**REGION-TO-AREA SCREENING METHODOLOGY
FOR THE
CRYSTALLINE REPOSITORY PROJECT**

APRIL 1985

**U.S. DEPARTMENT OF ENERGY
OFFICE OF CIVILIAN RADIOACTIVE WASTE MANAGEMENT
CRYSTALLINE REPOSITORY PROJECT OFFICE**

Figure 3 Crystalline Repository Project Report Schedule
Leading to Initiation of Area-Phase Field Work

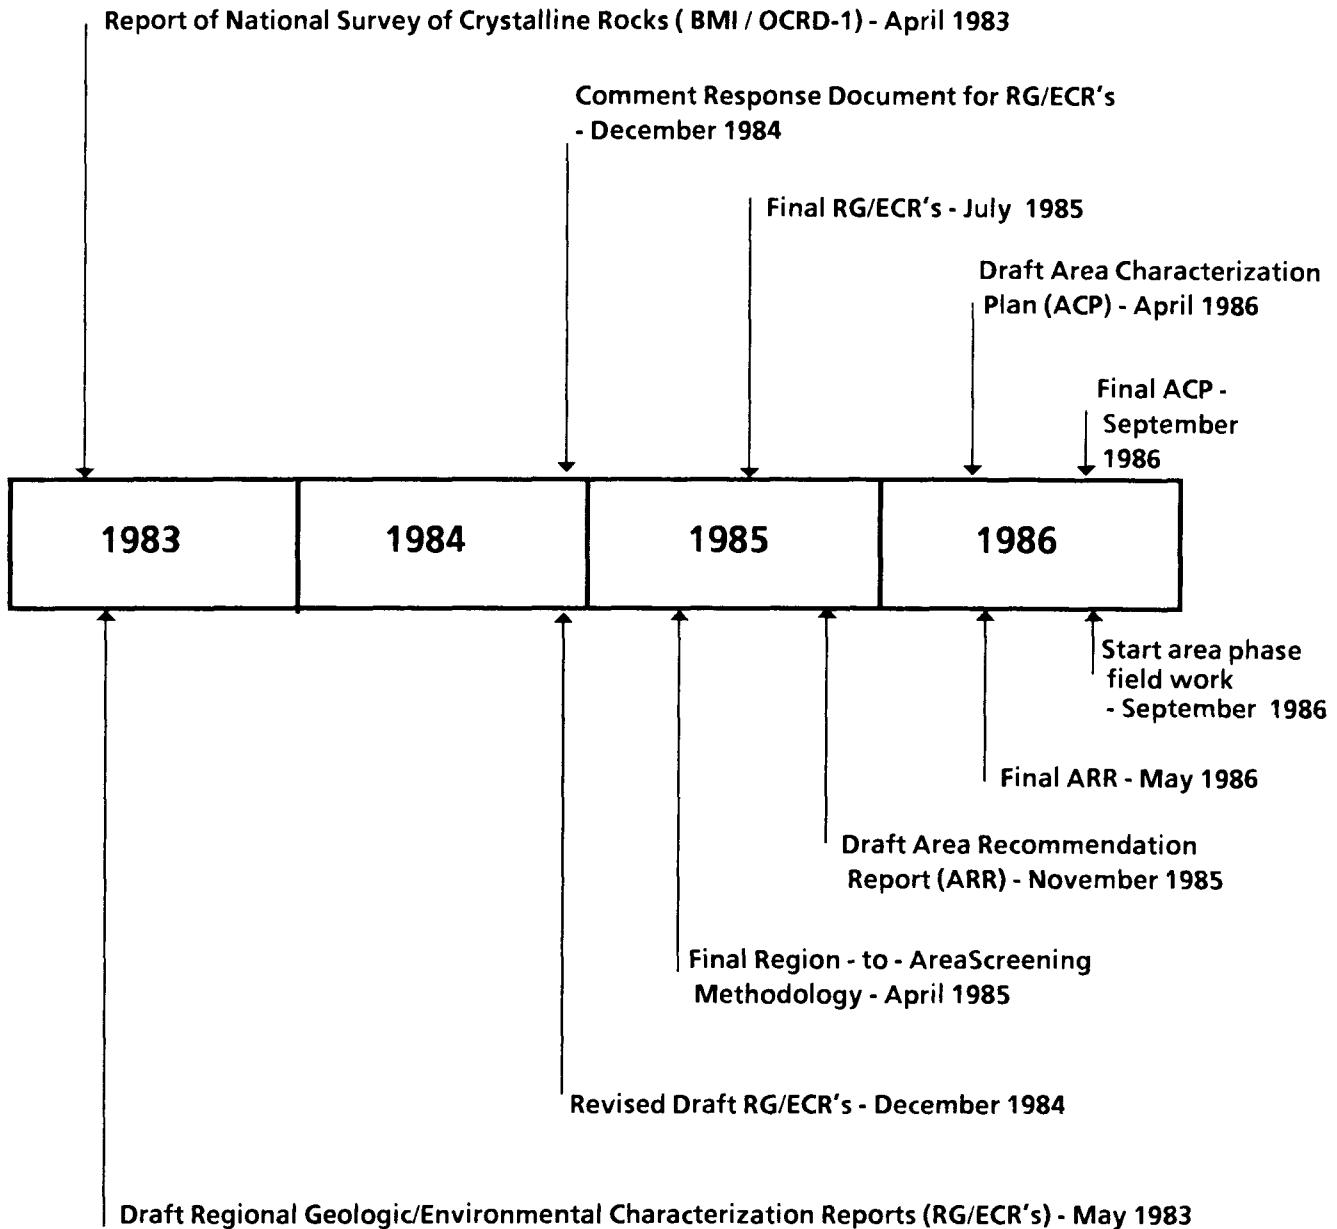
Figure 3 is no longer valid, as Comment Response Document for RE/GCR's not released in September, 1984.

Figure 3 has been modified to reflect the current CRP schedule through the initiation of area-phase field work.

Figure 8
Favorability Maps for Hypothetical Application of
Environmental/Socioeconomic Step 2 Variables

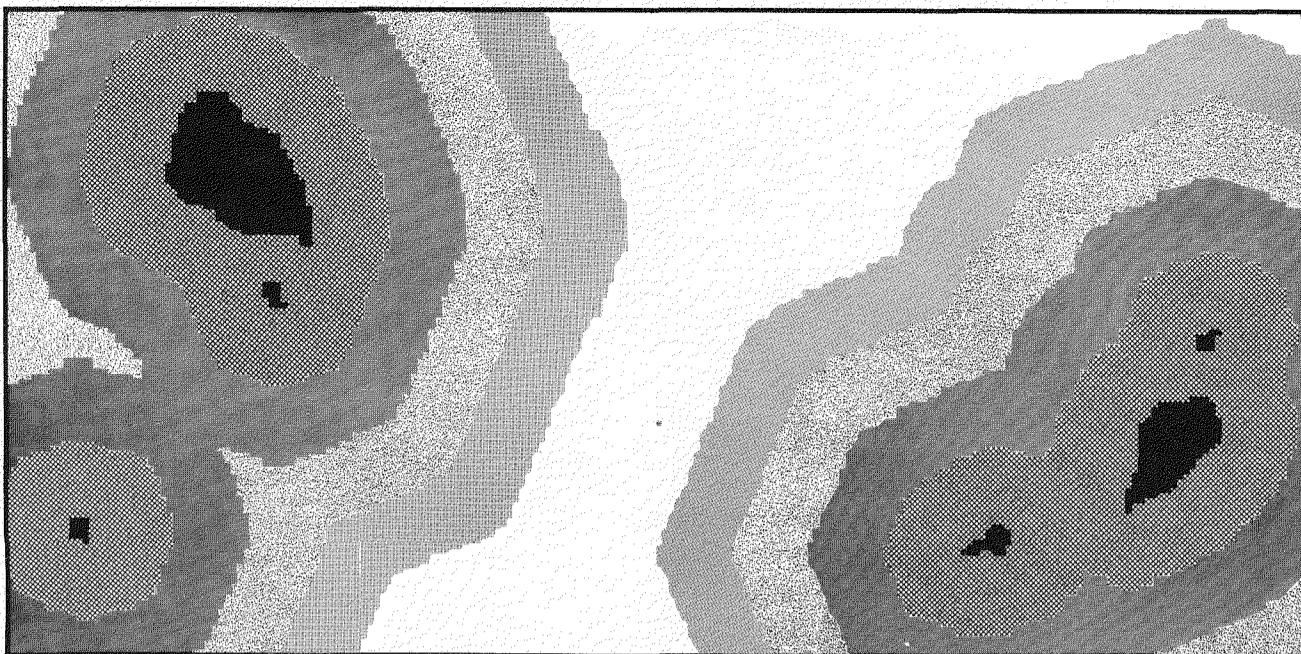
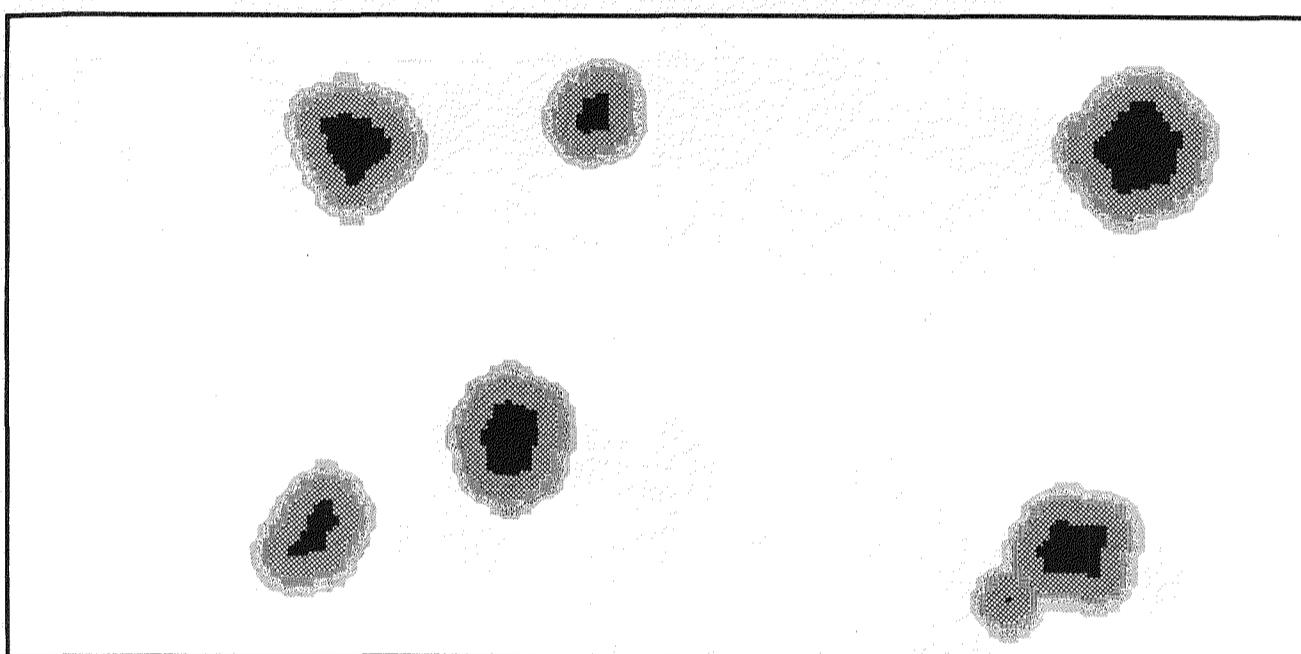
P. 24, Figure 8 - Why is shading for no. 2 darker than for no. 1? It would be logical for shading to become progressively lighter from no. 1 to no. 5. Also, it is difficult to distinguish in shading between "disqualified" and no. 2.

Figure 9 Favorability Maps for Hypothetical Application of Geologic Step 2 Variables.

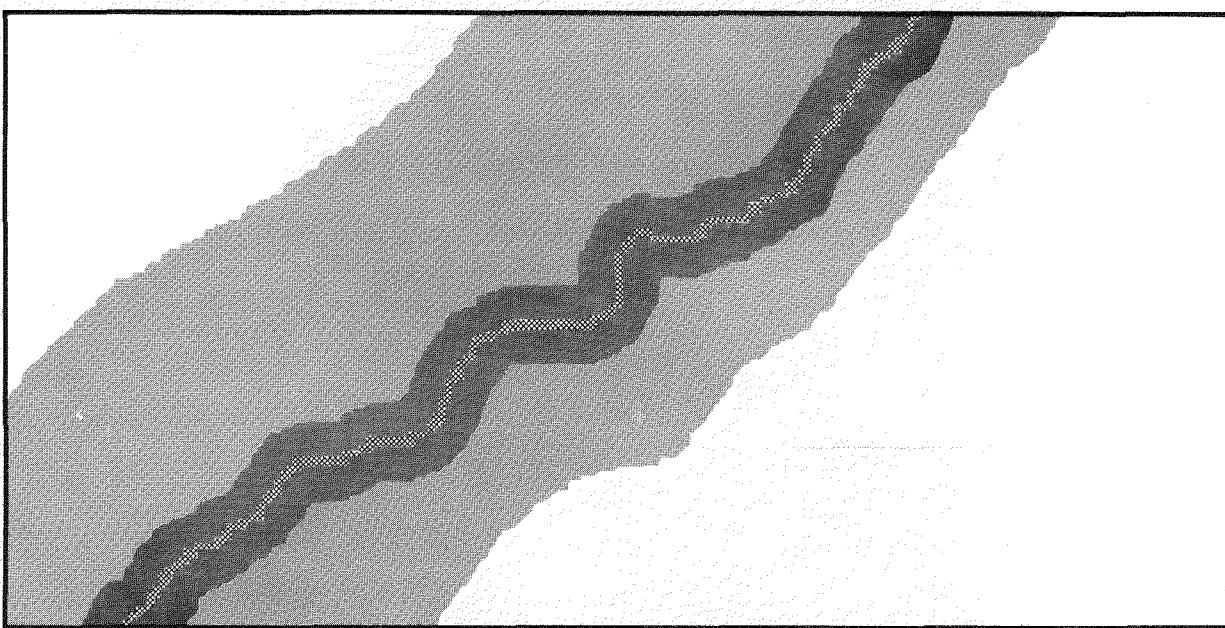
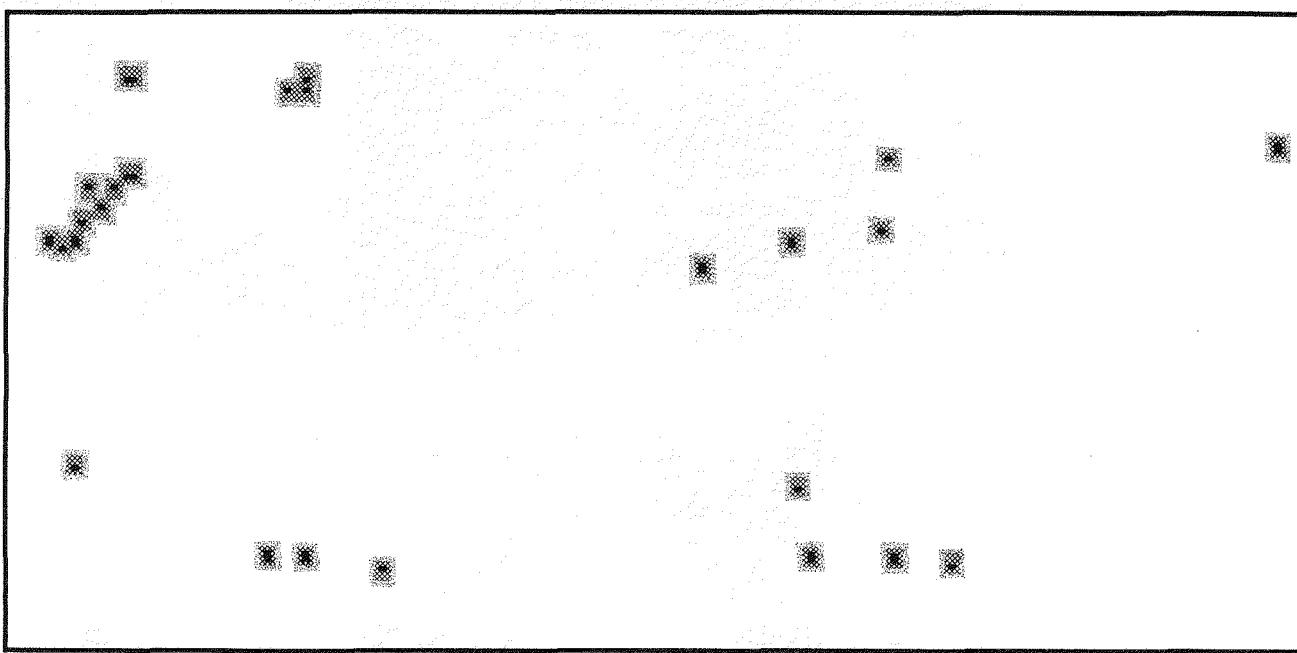
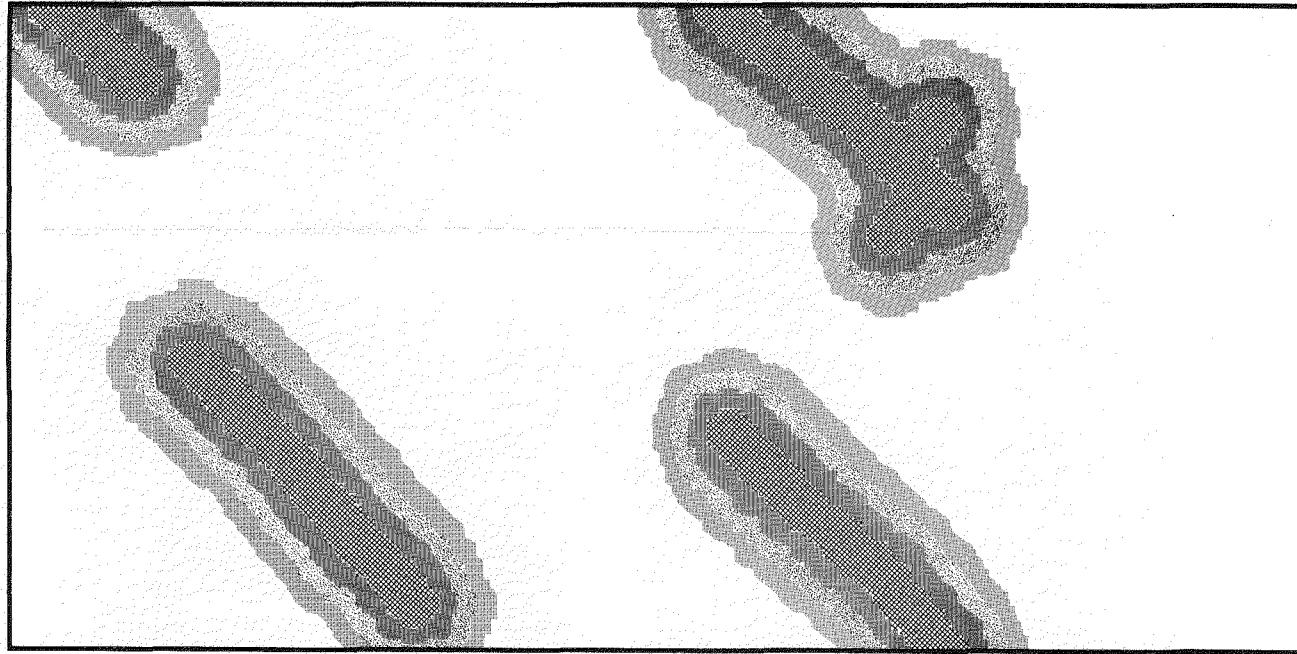
P. 25, Figure 9 - Comments same as for Figure 8. (VA-B-13)

Figure 11 Demonstration of the Composite Favorability Map Concept

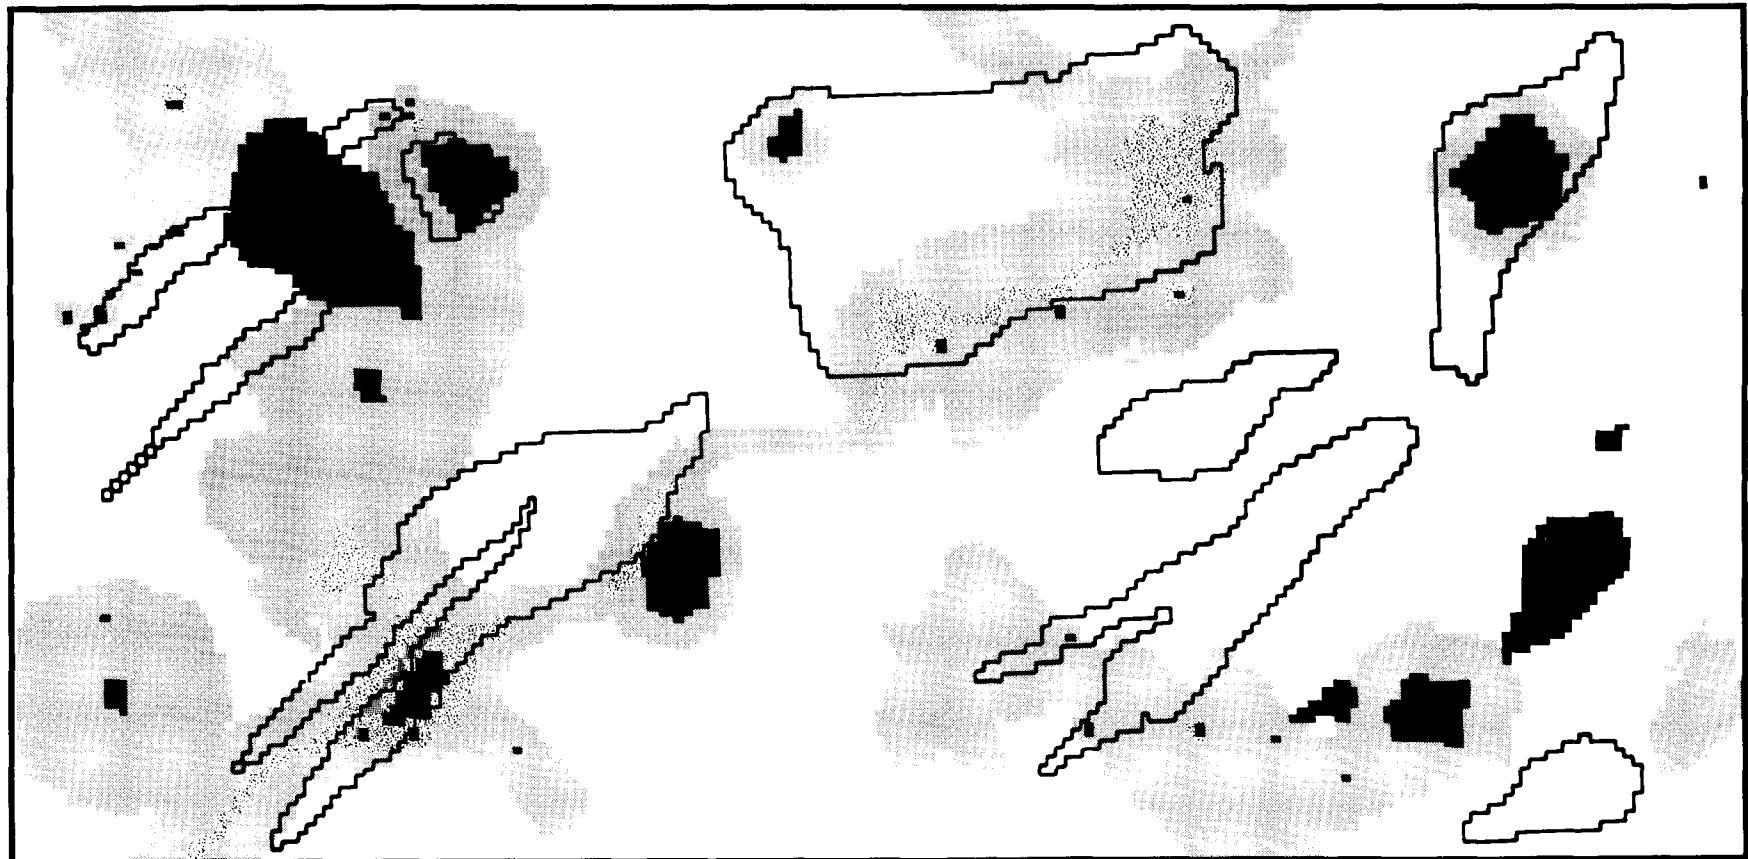
P. 39, Figure 11 - We assume that the grid-cells outlined by heavy lines are the rock bodies being considered. This should be so indicated in the legend.

P. 39, Figure 11 - Why are shadings for favorability shown far outside the rock-body boundaries?

The assumption is correct, and the use of these lines in previous figures as rock body boundaries is continued in Figures 11 and 12.

Figure 11 provides a simplified example of what a composite map may look like. The shadings are depicted in that manner to help orient the reader as to which features proximate to the rock body influence its favorability. It is recognized that only areas within a rock body boundary will be studied further as the location for a repository. It is CRP's current plan to depict only rock bodies on the composite maps.

Figure 13 Schematic Diagram of Drainage Basin, Showing the Major Stream (Ground-Water Discharge Zone) and Drainage Divide

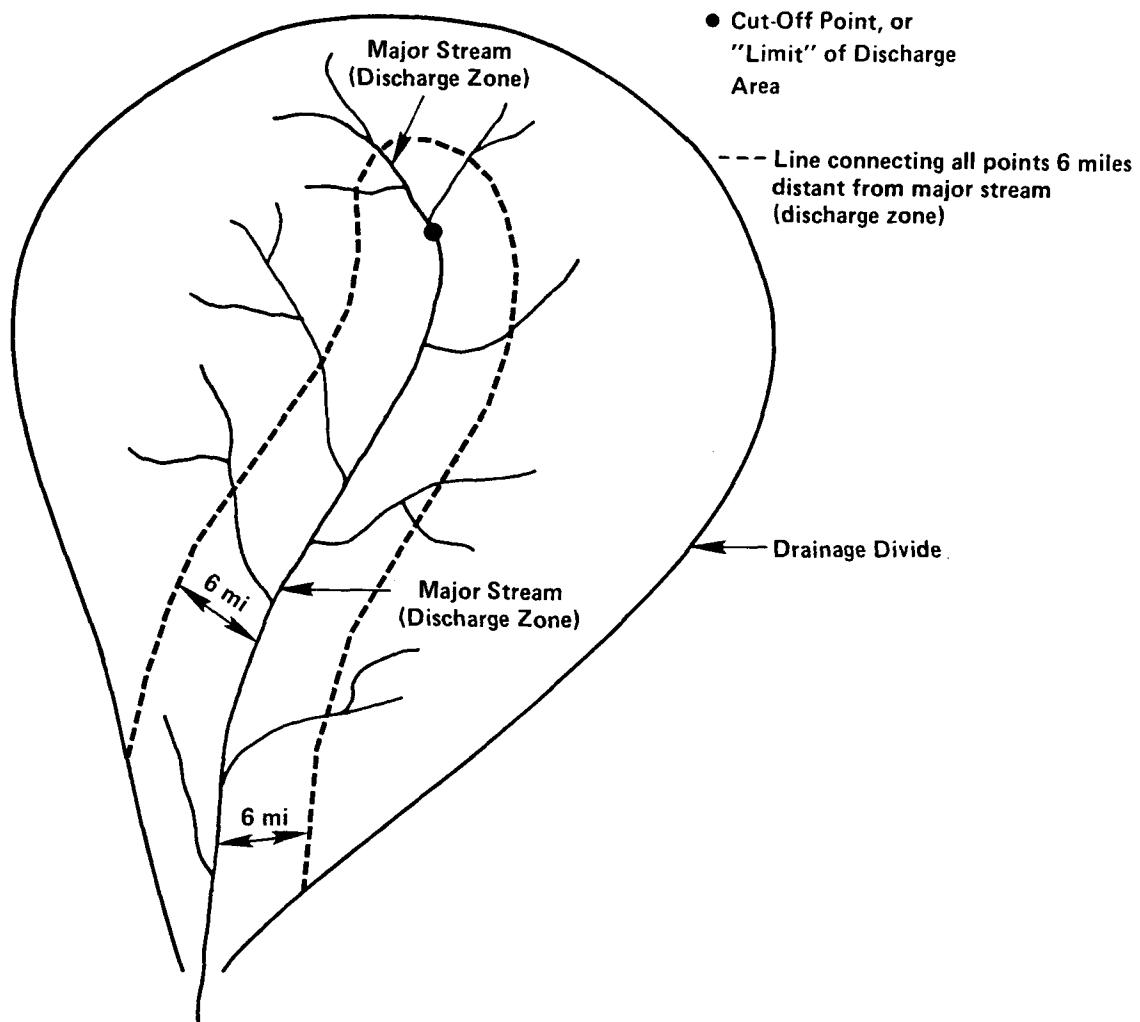
It is not clear to the uninformed reader what a "cut off point" is. Also, it would be helpful to label the "hinge line" on Figure 13.

This section has been rewritten, and the "cutoff point" is now explained. Figure 13 has been revised, and the "hinge line" is no longer used as part of the measure for the variable.
